ADDENDUM No. 1

RFP No. 26-20

Packard Water Main, Mallets Creek

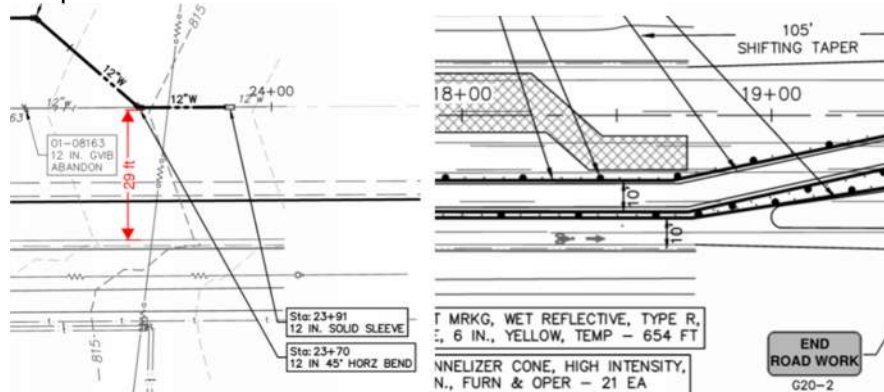
Question 1: The HDPE pipe will need to be fused prior to pulling through the bore. This will require a staging area slightly longer than the proposed bore. Please consider extending the PH1 MOT lane closure to the West 600 +/- feet to accommodate the pre-fused length of pipe.

Answer 1: The MOT for Phase 1 was extended an additional 350 feet east of the bore pit; the gas station needs to maintain access to the easterly driveway.

PACKARD ROAD TYPICAL SECTION
N.T.S.

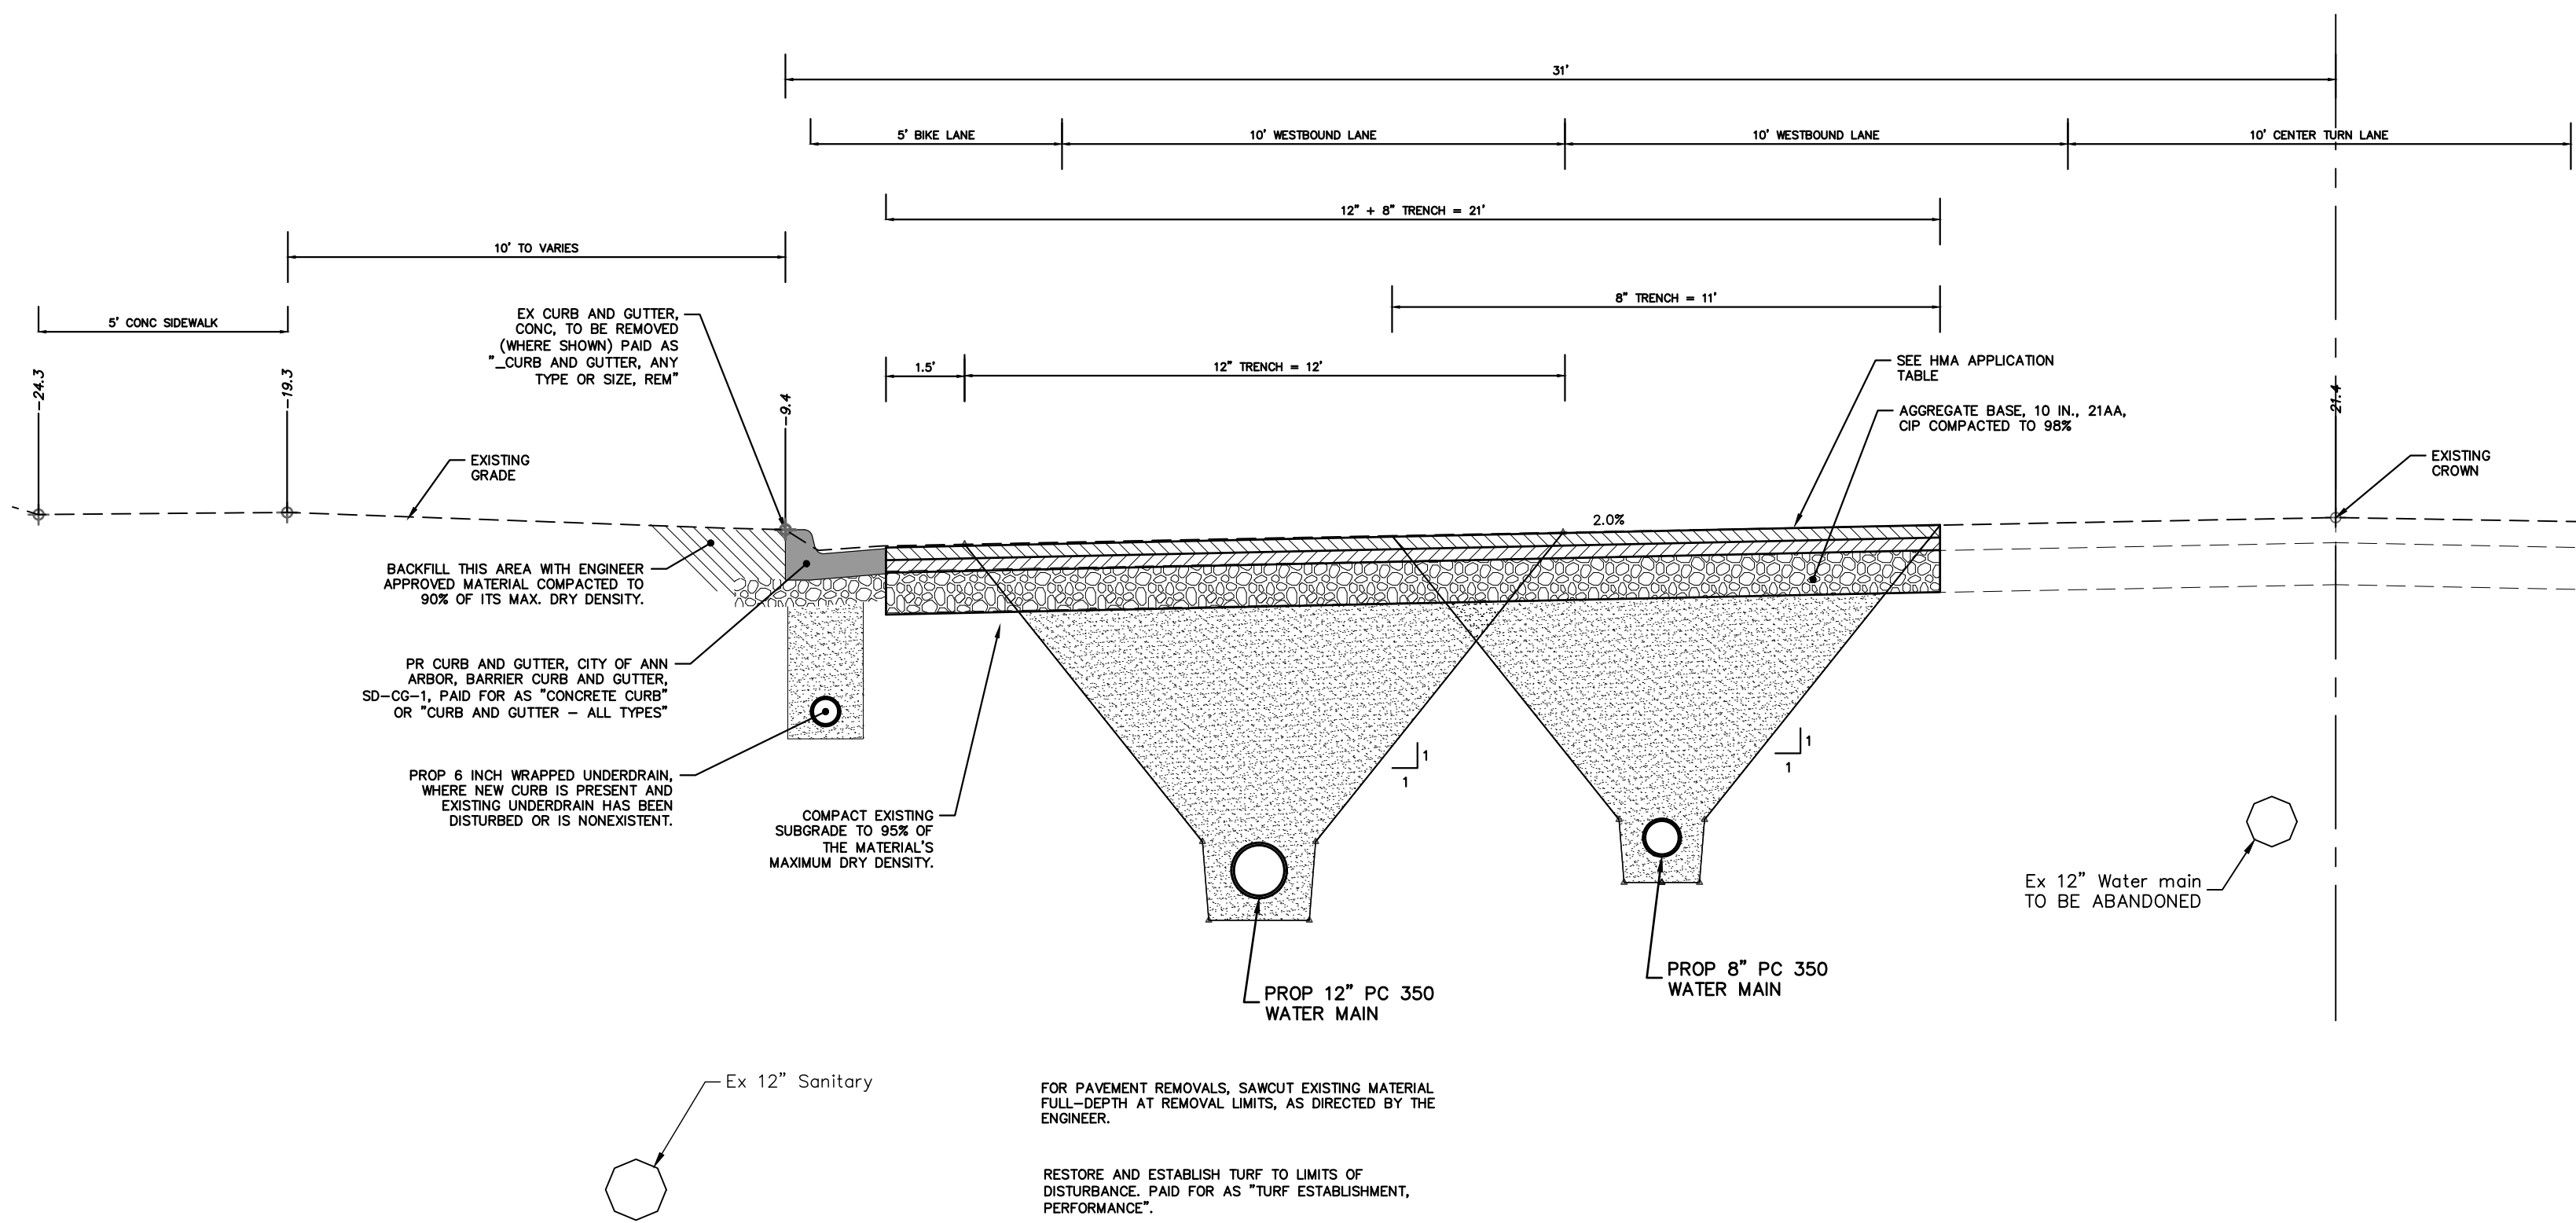
Question 11: Please provide the proposed road restoration cross section.

Question 27: Can a proposed section/typical be provided for the HMA roadway areas?

Answer 11: The proposed pavement cross section has been added to the plans.

Answer 27: A typical section has been added to the plans.

CITY OF ANN ARBOR - PUBLIC SERVICES - ENGINEERING
PACKARD WATER MAIN MALLETS CREEK
 PACKARD WATER MAIN PLAN & PROFILE
 P.O.B. - STA. 20+50

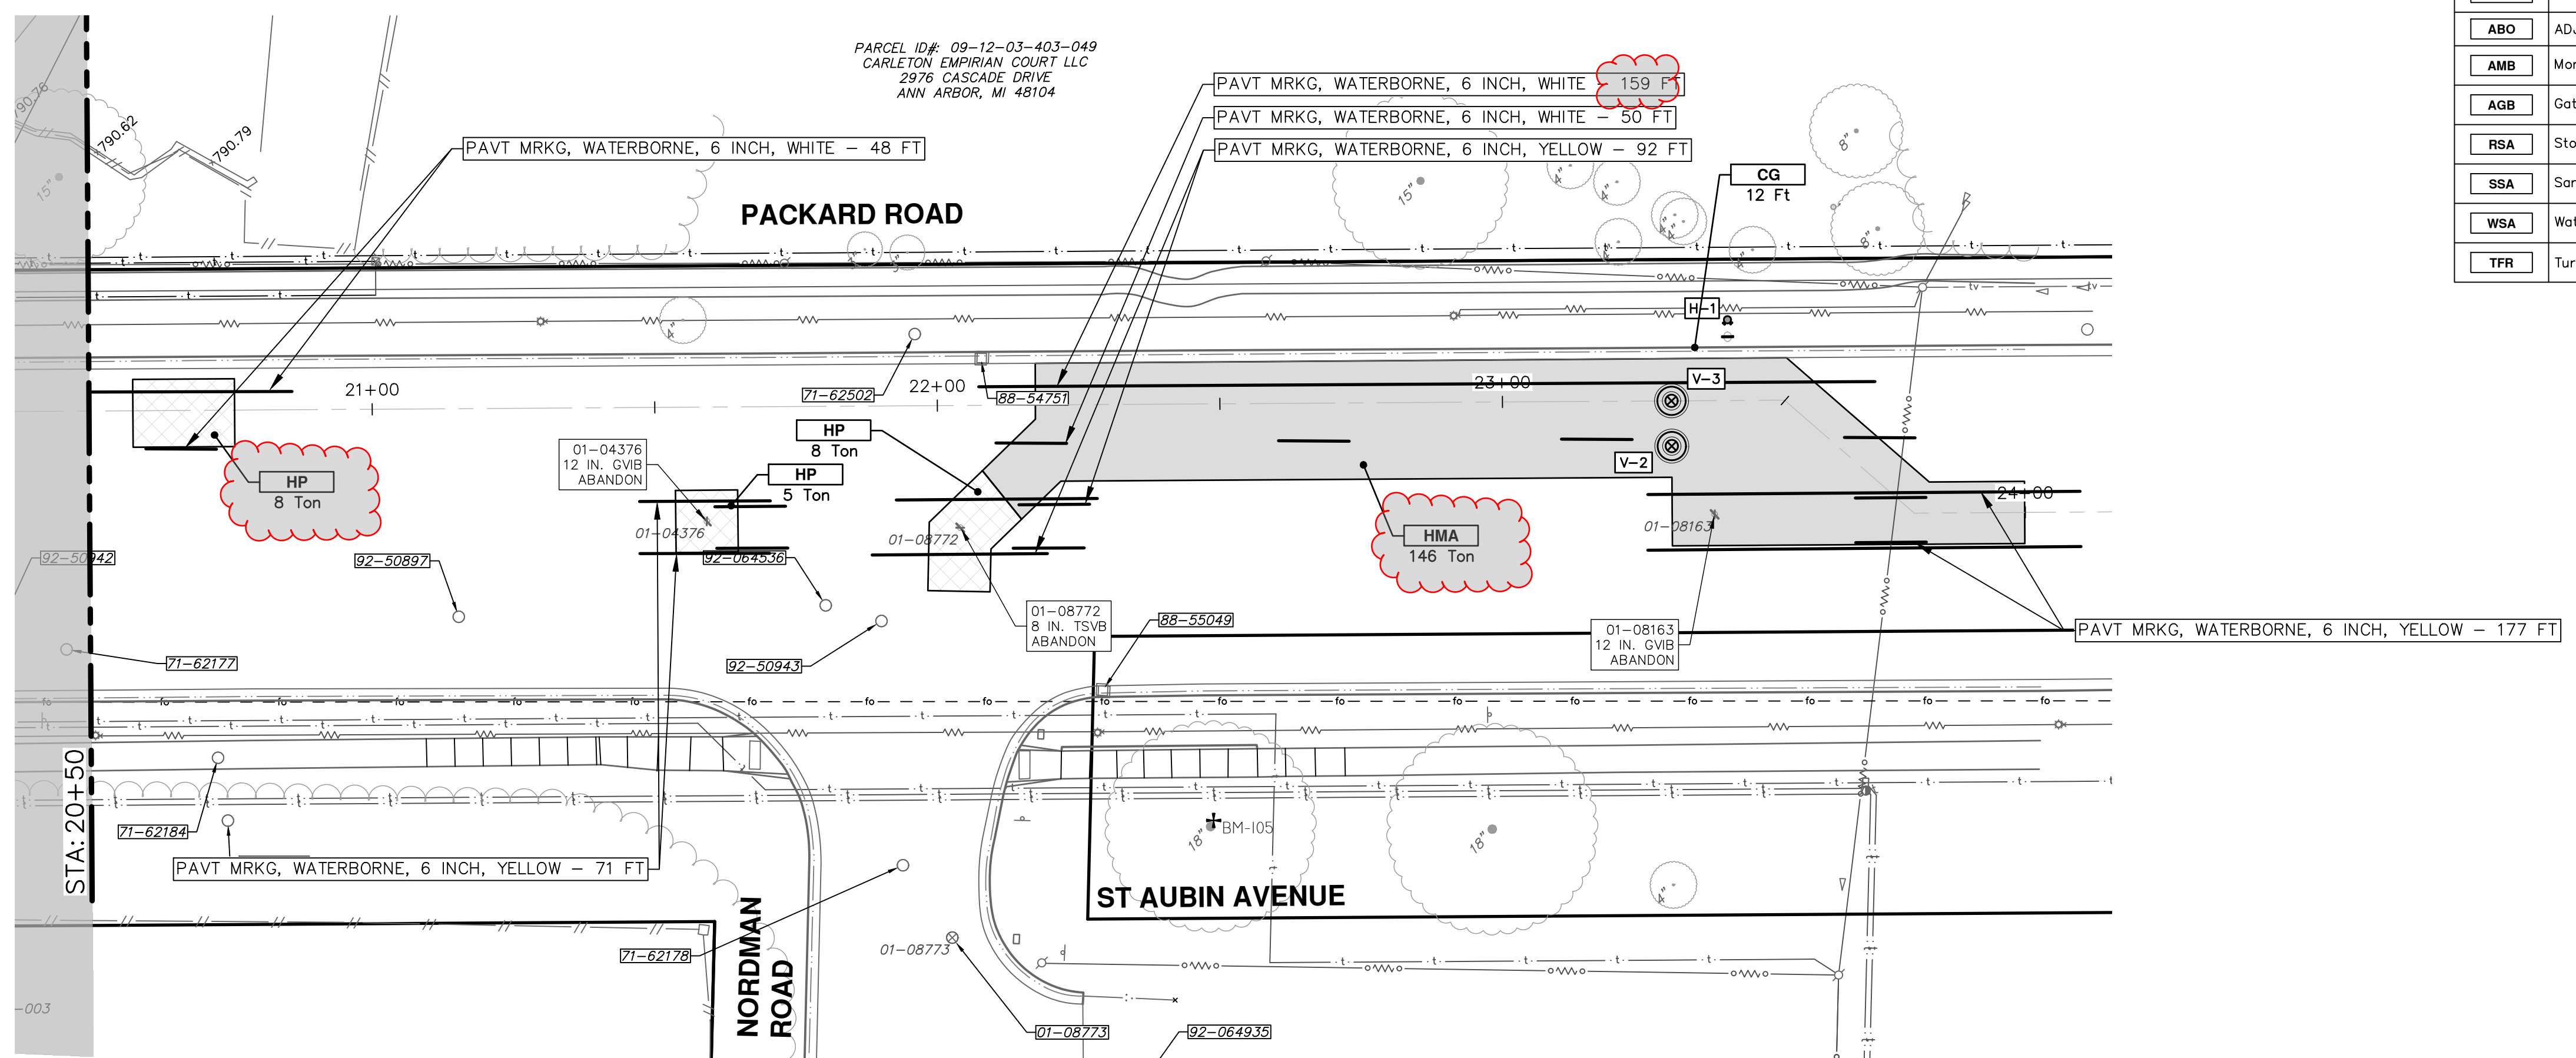
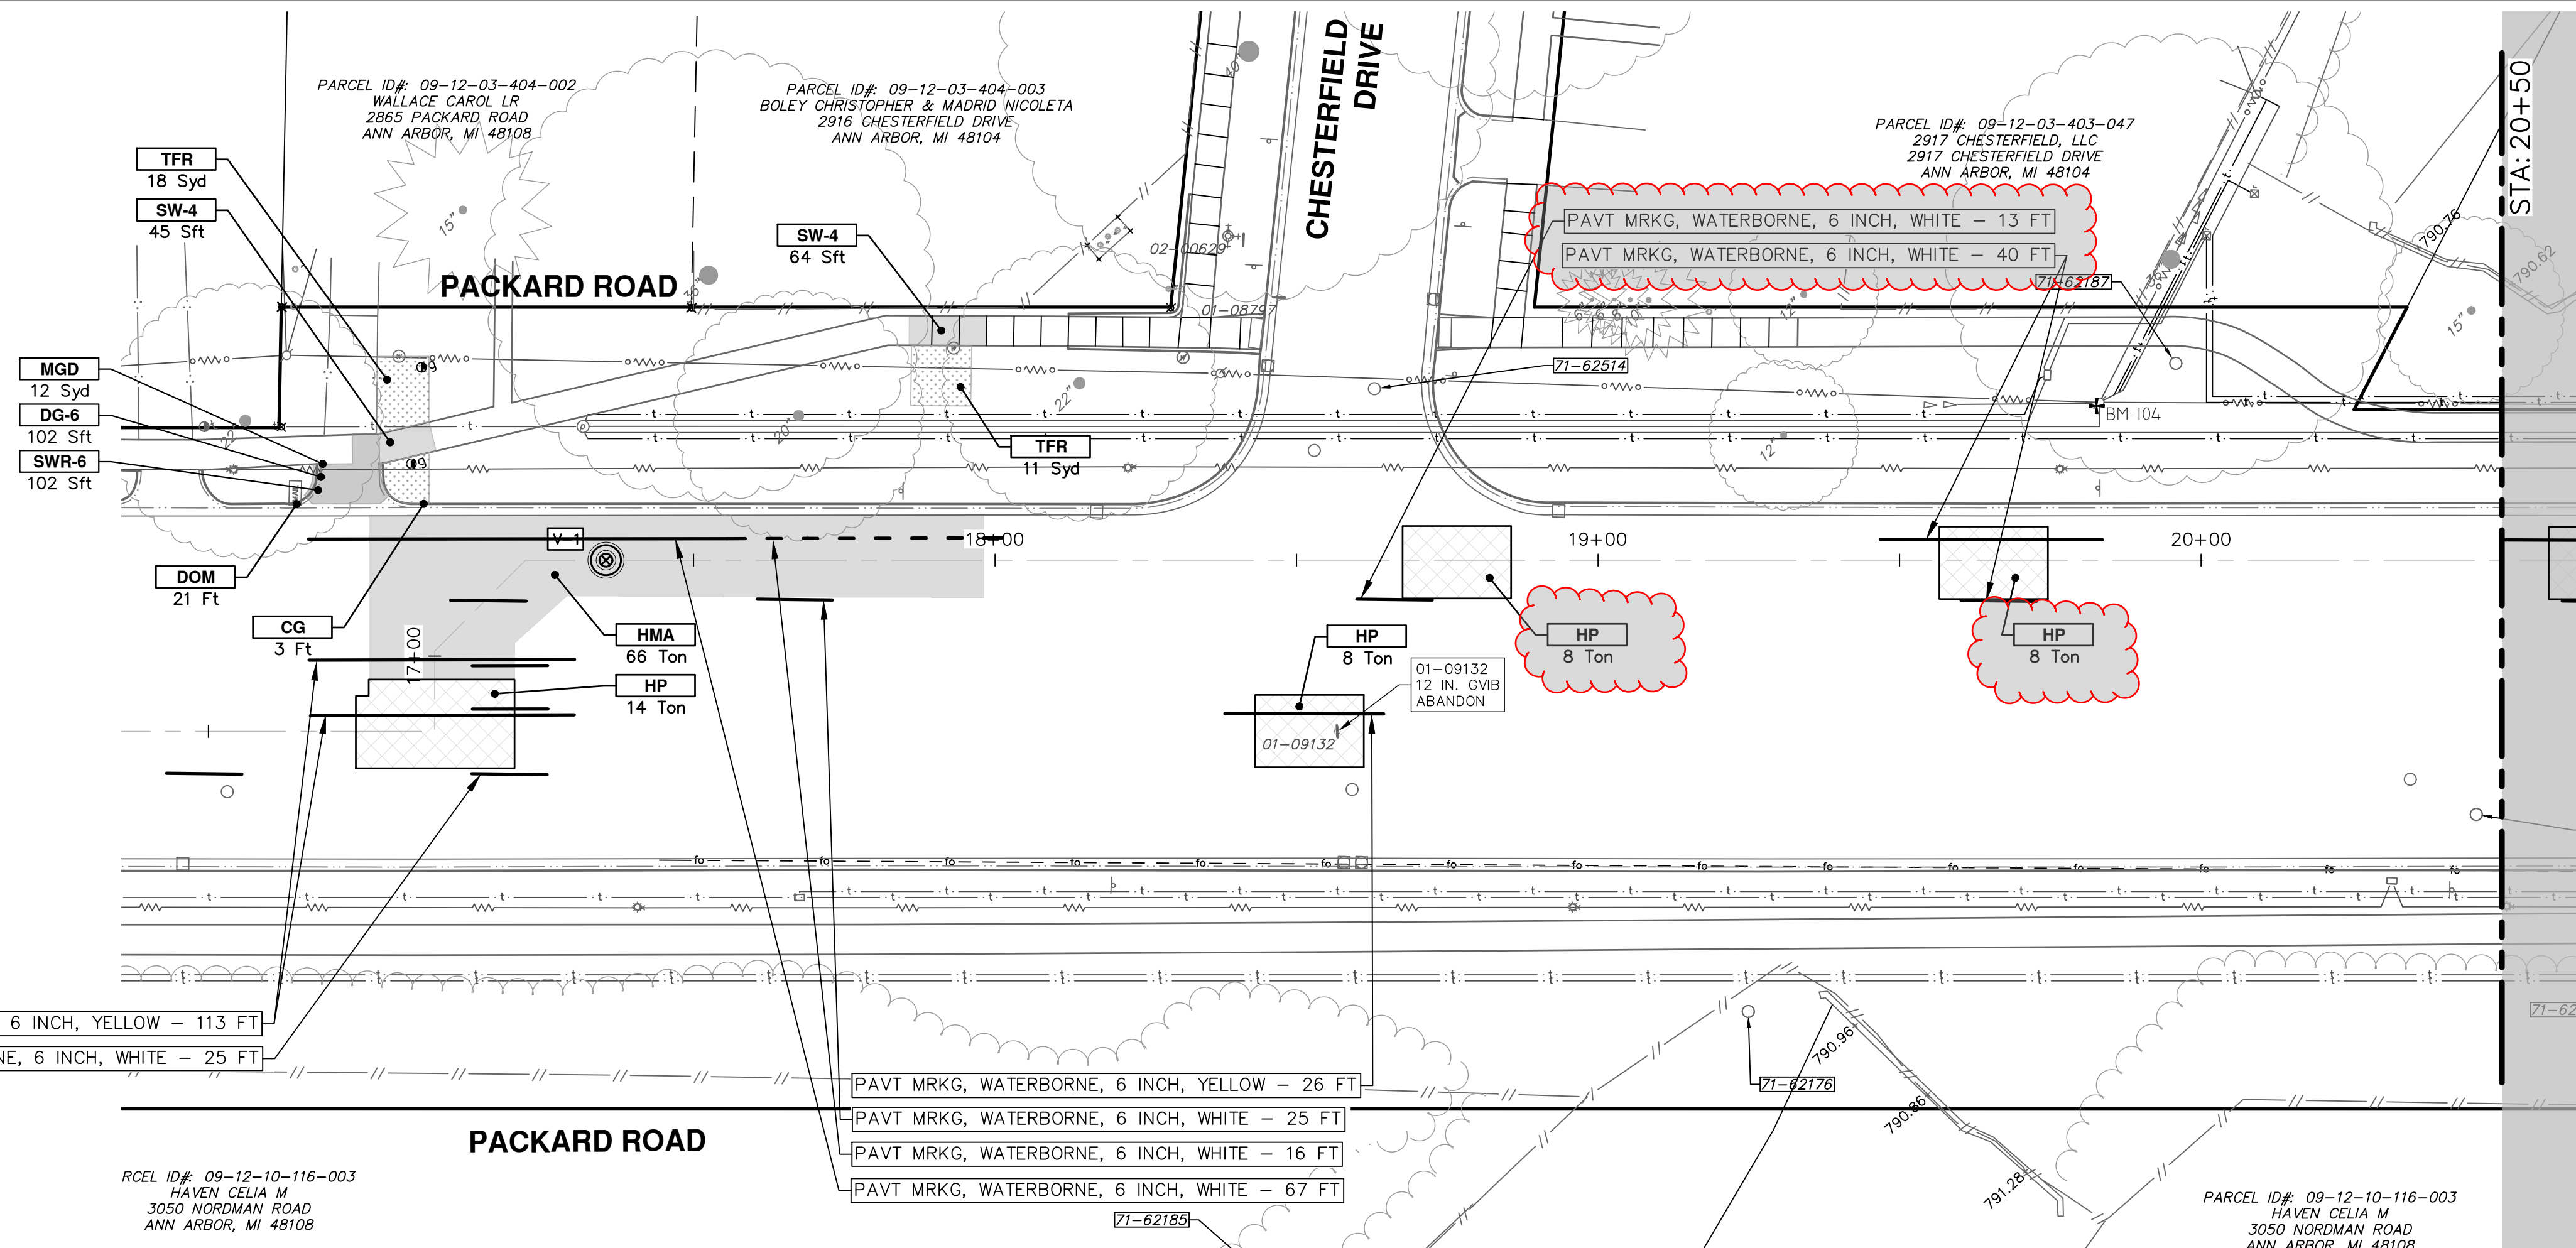
Question 3: The existing 6" gas crosses the proposed water main at approximately station 18+00 per the plan view and is not depicted on the profile. This gas crossing will need to be exposed and verified prior to drilling. The removal and restoration plans do not show this pavement to be removed and replaced. How pavement removal and replacement to be paid for locating the existing gas elevation?

Question 5: The proposed water main profile shows 18" separation from the existing sanitary mains. The proposed water main will need to be lowered at least 5'-10' to eliminate or limit potential damage to the existing sanitary sewer.

Answer 3: The gas main crossing was added on Sheet 9. See cross-section.

Answer 5: The HDD was lowered and additional separation was provided as shown in the plans.
